UNITED STATES
NUCLEAR REGULATORY COMMISSION

SUBJECT: ISSUANCE OF AMENDMENT - MILLSTONE NUCLEAR POWER STATION, UNIT
NO. 3 (TAC NOS. M98035 AND M99502)

The Commission has issued the enclosed Amendment No. 157 to Facility Operating License No. NPF-49 for the Millstone Nuclear Power Station, Unit No. 3, in response to your application dated August 29, 1997, as supplemented by letters dated September 25 and November 14, 1997.

Based on a review and subsequent calculations of the cold overpressurization protection (COPS) enabling temperature and the emergency core cooling system (ECCS)/charging system mode 3 requirements, Northeast Nuclear Energy Company (NNECO) proposes to reduce the COPS enabling temperature. As a result, NNECO proposed the following Technical Specifications (TS) changes: add new heatup and cooldown pressure/temperature limit curves and their associated requirements; add new power operated relief valve (PORV) setpoint curves and their associated requirements; revise the reactor coolant loops and coolant circulation, ECCS, boration systems, and COPS to incorporate the lower enabling temperature and new restrictions for cold overpressure protection system, PORV undersh

FIGURE 3.4-2

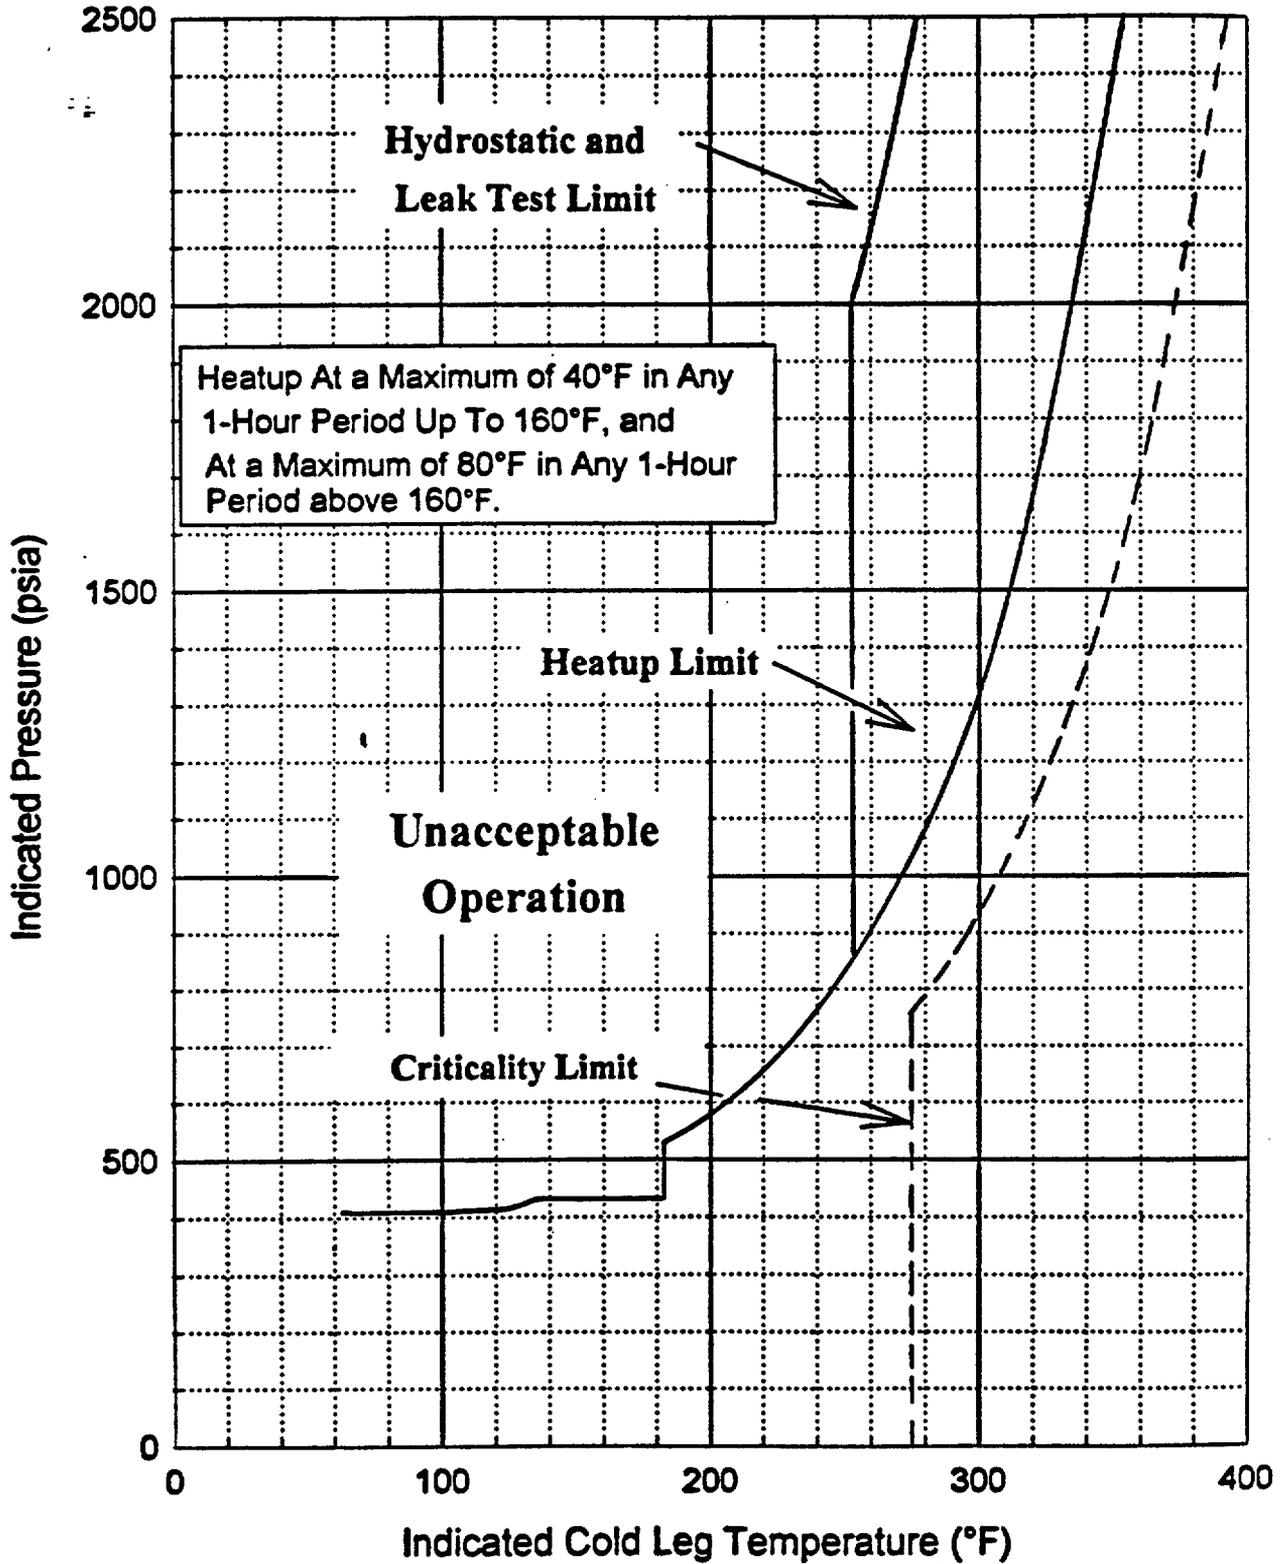
- a. During an RCS heatup, the heatup limits of Figure 3.4-2 apply with the additional restriction that only one reactor coolant pump can be operating when the lowest unisolated RCS loop wide range cold leg temperature is $\leq 160^{\circ}\text{F}$.

The LCO and Figures 3.4-2 and 3.4-3 contain P/T limit curves for heatup, cooldown, inservice leak and hydrostatic (ISLH) testing, and data for the maximum rate of change of reactor coolant temperature.

The ARTs calculated by the staff and the licensee are almost identical. However, substituting the ART of 111.9 °F into equations in SRP 5.3.2, the staff could not verify the proposed P-T limit curves. In its response to the staff's request, the licensee, in a letter dated September 25, 1997, provided details of the methodology used. This information revealed that Millstone Unit 3 has some unique features built into the P-T limits: (1) the proposed P-T limits considered indicator uncertainties, 22 °F for temperature and 129 psia for pressure; (2) it considered a pressure drop of 28.3 psi between the pressure transmitter and the reactor vessel beltline for one pump operation and a pressure drop of 74 psi for four pump operation; (3) the cooldown curve is made of the conservative portions of the P-T limits at a cooldown rate of 0 °F/hr and the P-T limits at a cooldown rate of 80 °F/hr to 160 °F and 40 °F/hr to 60 °F; and (4) the pressure was expressed in "psia," with a value of 10 added to the gage pressure to account for the primary containment pressure. After considering the extra conservatism in (1) (2), and (3), the staff confirmed the proposed P-T limits (for 10 EFPY) for heatup, cooldown, and hydrotest and concluded that they meet the beltline material requirements in Appendix G of 10 CFR Part 50. The staff found that all equations involving the conversion of the pressure in psig to psia in Reference 2 had a sign error. However, from the intermediate results presented, the staff verified that the correct sign was used in actual calculations.

Figure 3.4-3

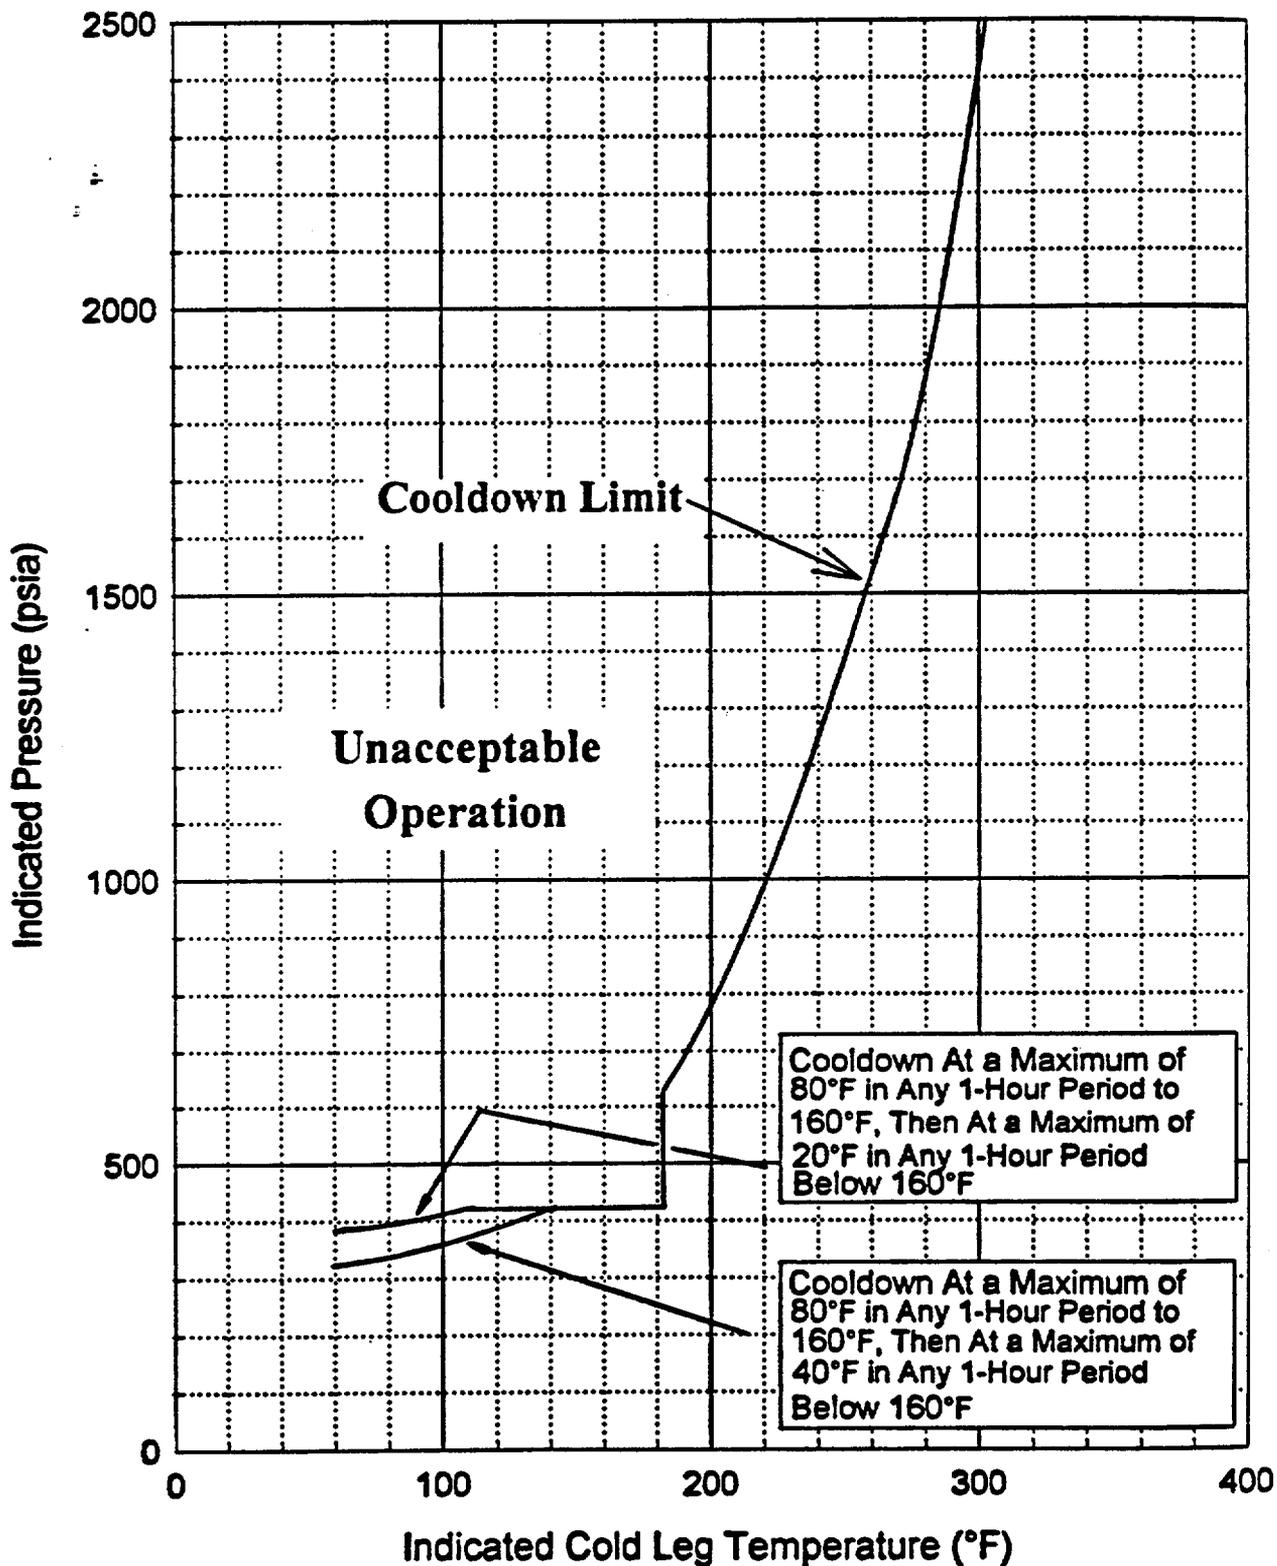
- b. During an RCS cooldown, the limits of Figure 3.4-3 apply with the additional restriction that only one reactor coolant pump can be operating when the lowest unisolated RCS loop wide range cold leg temperature is $\leq 160^{\circ}\text{F}$ and no reactor coolant pump may be operated when the lowest unisolated RCS loop wide range cold leg temperature is $\leq 120^{\circ}\text{F}$.

FIGURE 3.4-4a

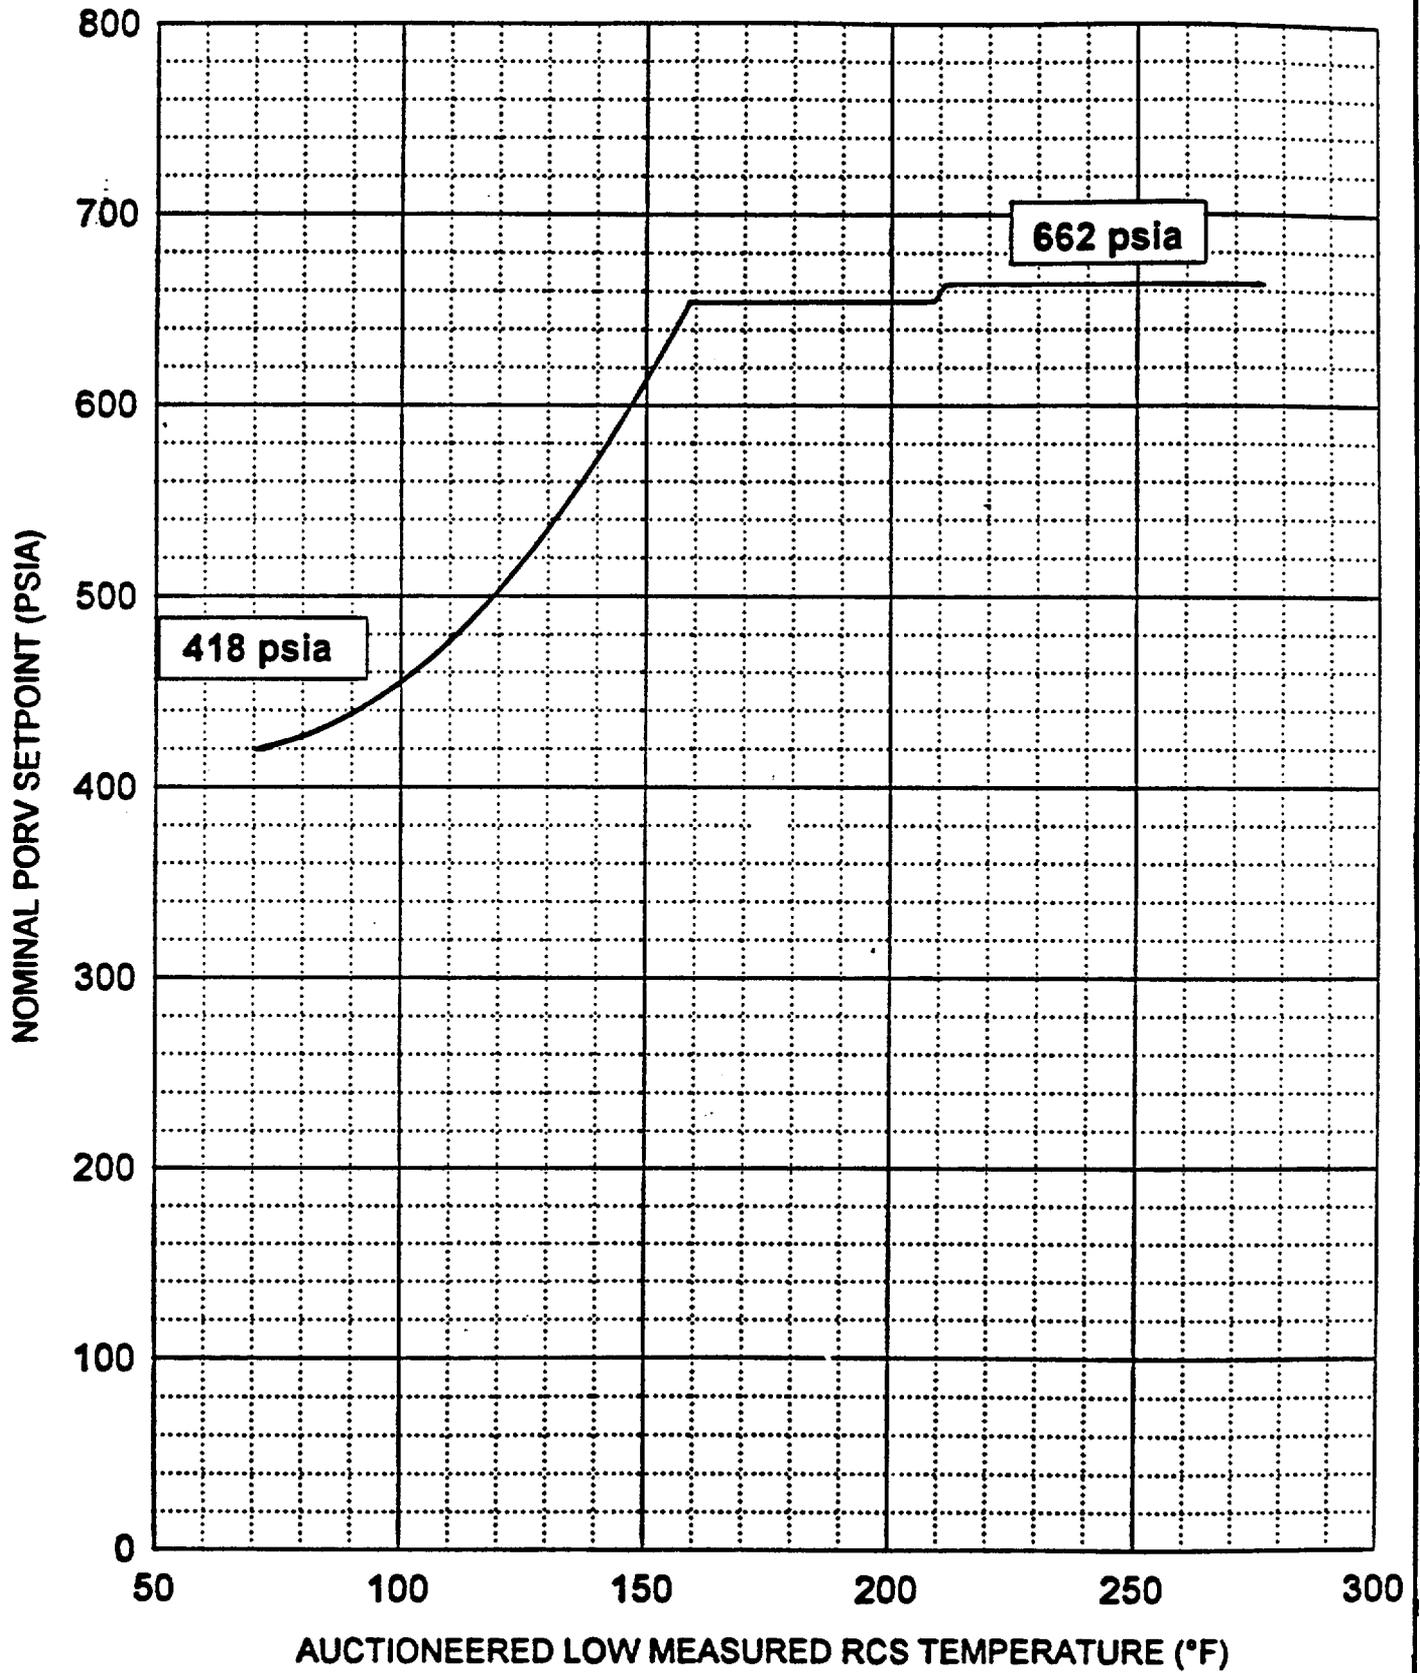
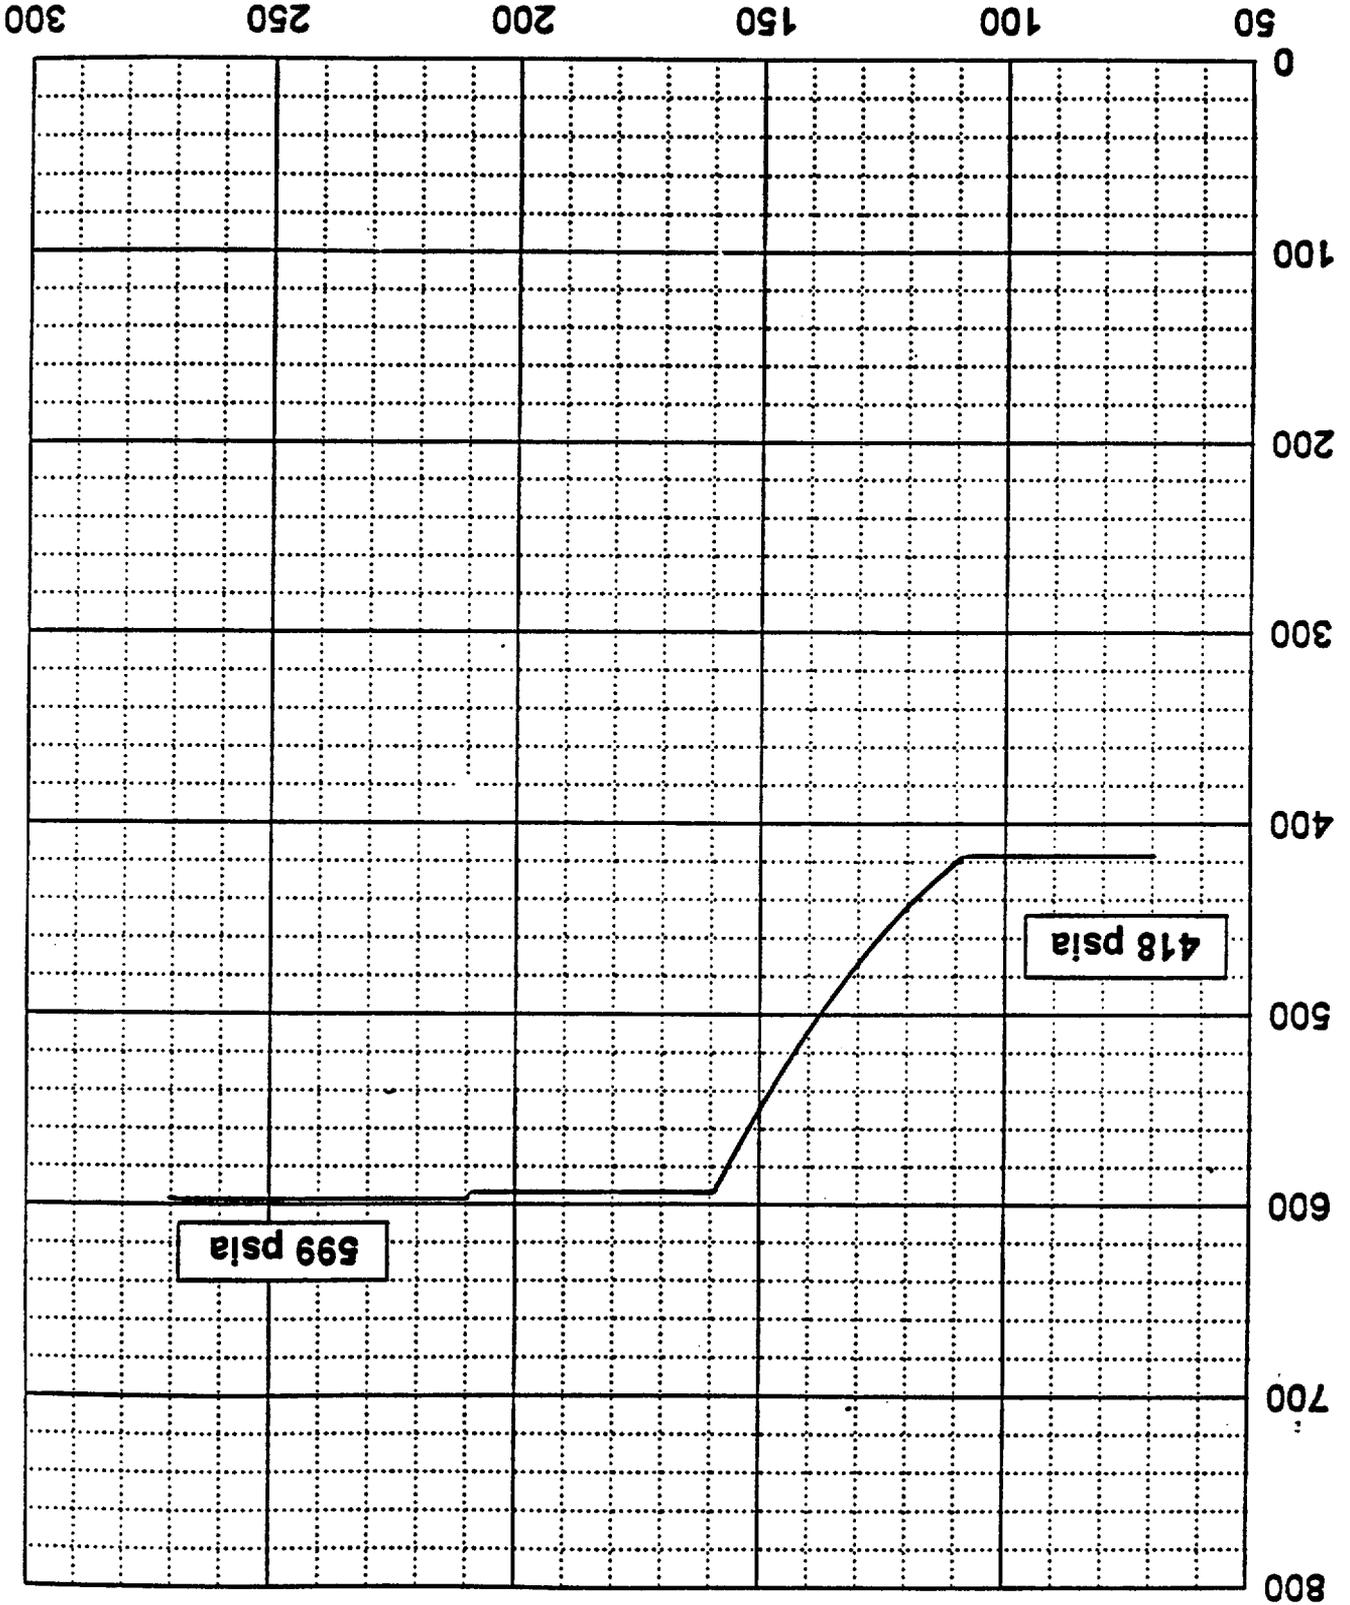
1. One power operated relief valve (PORV) with a nominal lift setting established in Figure 3.4-4a and one PORV with a nominal lift setting established in Figure 3.4-4b, or
2. Two residual heat removal (RHR) suction relief valves with setpoints ≥ 426.8 psig and ≤ 453.2 psig, or
3. One PORV with a nominal lift setting established in Figure 3.4-4a or Figure 3.4-4b and one RHR suction relief valve with a setpoint ≥ 426.8 psig and ≤ 453.2 psig, or
4. RCS depressurized with an RCS vent of ≥ 5.4 square inches.

Figure 3.4-4a and Figure 3.4-4b present the PORV setpoints for COPPS. Above 110°F, the setpoints are staggered so only one valve opens during a low

temperature overpressure transient. Setting both valves to the values of Figure 3.4-4a and Figure 3.4-4b within the tolerance allowed for the calibration accuracy, ensures that the Reference 1 limits will not be exceeded for the analyzed isothermal events.

The licensee proposed PORV actuation setpoints in TS Figures 3.4-4a and 3.4-4b were calculated in accordance with the proposed methodology. In response to the staff request, the licensee, in its letter dated November 14, 1997, provided a tabulation to list PORV setpoint, transient pressure overshoot, instrumentation uncertainties for temperature and pressure and corresponding P-T limit under various temperature conditions below the COPS enable temperature. The data presented in this tabulation confirms that the proposed PORV setpoints will provide adequate protection to the 10 CFR Part 50, Appendix G, P-T limits under steady state conditions during a design basis overpressure transient (mass-addition or heat-addition) as described in Section 3.1 of this safety evaluation. Based on the preceding discussion, the staff finds the proposed PORV setpoint acceptable.
